Meeting of: BUSINESS PARK NORTH COMMITTEE OF THE CITY OF STOUGHTON

- 1. Call to Order
- 2. Elect Chair
- 3. Elect Vice-Chair
- 4. Consider approval on the BPN Committee Minutes of April 13, 2020.
- 5. Request by Edward and Patricia Bierer of Stellar Services for approval of a building addition at 301 Business Park Circle.
 - Recommendation to Plan Commission
- 6. Future agenda items.
- 7. Adjournment.

I have completed a final review of the proposed building addition/site plan for Stellar Services, LLC., 301 Business Park Circle. This item is planned to be on the Plan Commission and Business Park North agendas for May 11, 2020 of which you will receive notice. This project is also subject to the Business Park North Covenants as outlined below. As noted, additional information may be required to be provided or shown on the plan.

Site Plan

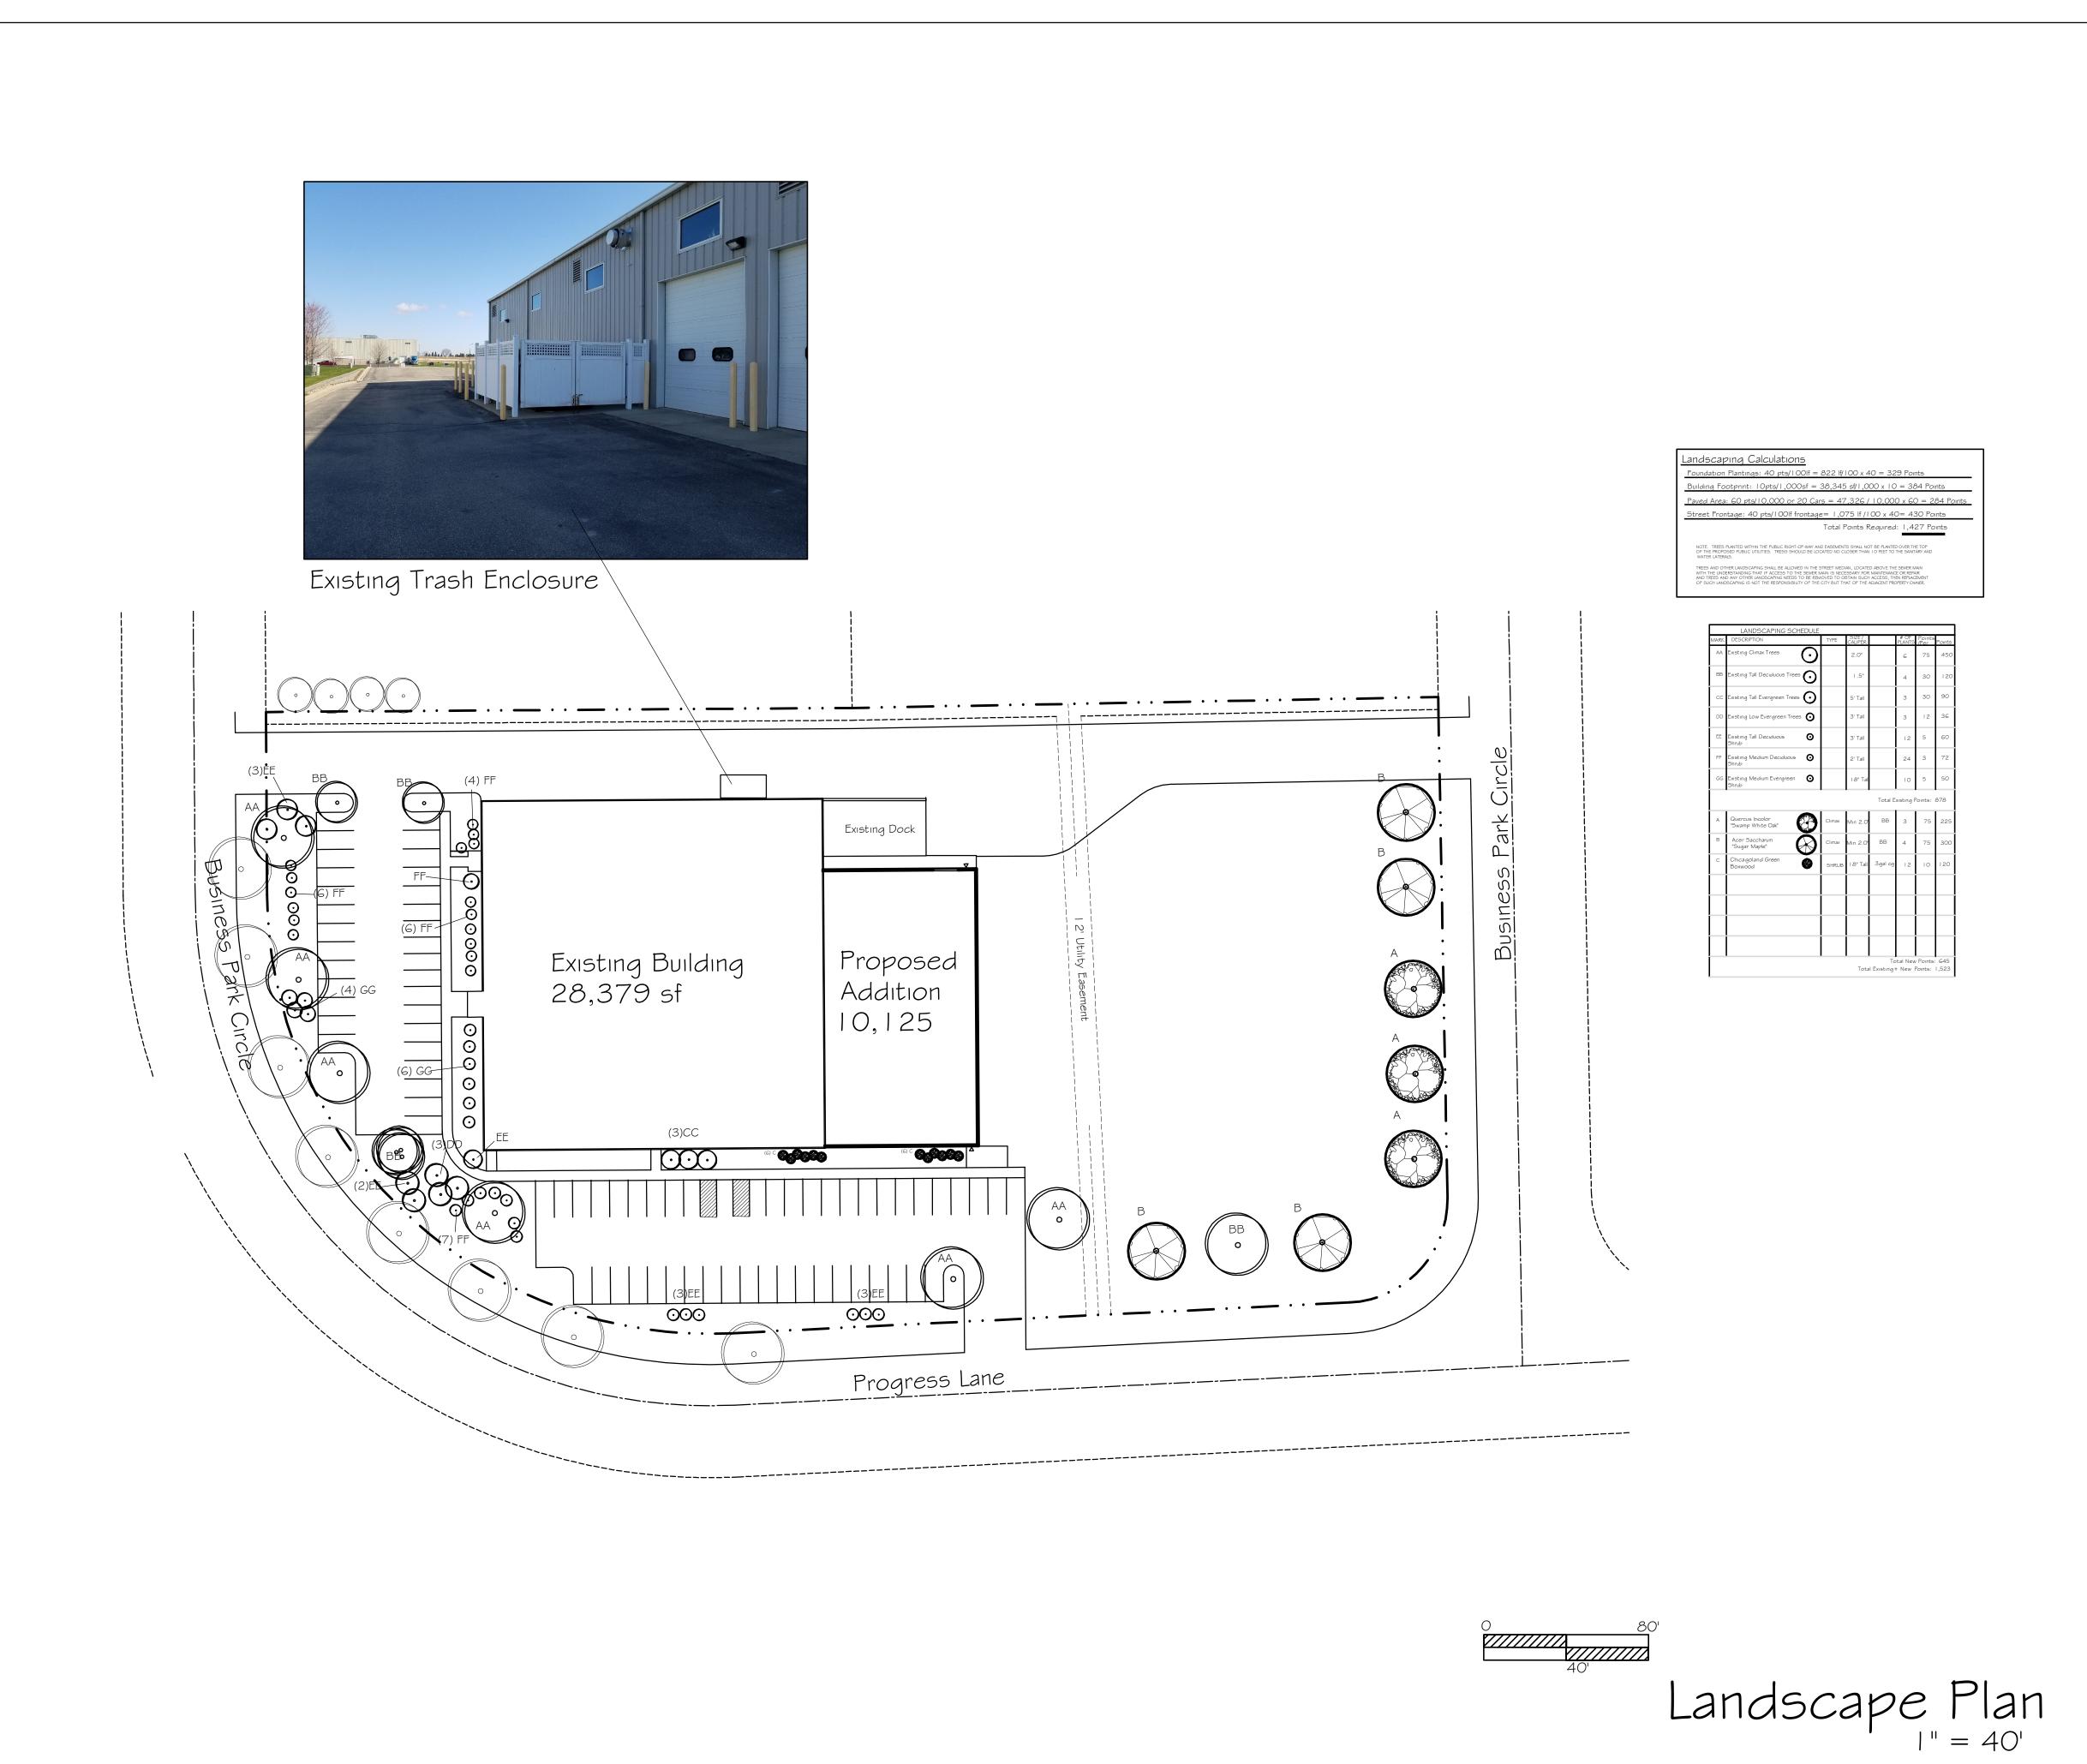
- 3. The parking requirement for wholesale uses are one space per 2,000 square feet of gross floor area. 20 parking spaces are required. There is more than ample existing parking spaces.

- 4. The Comprehensive Plan, Future Land Use Map designates this property as Planned Industrial which is consistent with the zoning and existing use.
- 5. The following are the minimum building setback and maximum height requirements of the Planned Industrial district: Front yard setback 20 feet; Side yard setback 10 feet; Rear yard setback 20 feet; Max building height 40 feet. **The plan meets these requirements.**

- 9. Per section 78-704 (13)(a), bicycle parking is required equal to 10% of the automobile parking space requirement. There are specific requirements related to bicycle parking in section 78-704 (13)(c). **Two bike stalls are delineated on the plan.**

- 10. The maximum floor area ratio is 1. This is calculated by dividing the total floor area of all buildings by the gross site area. **The plan meets this requirement.**
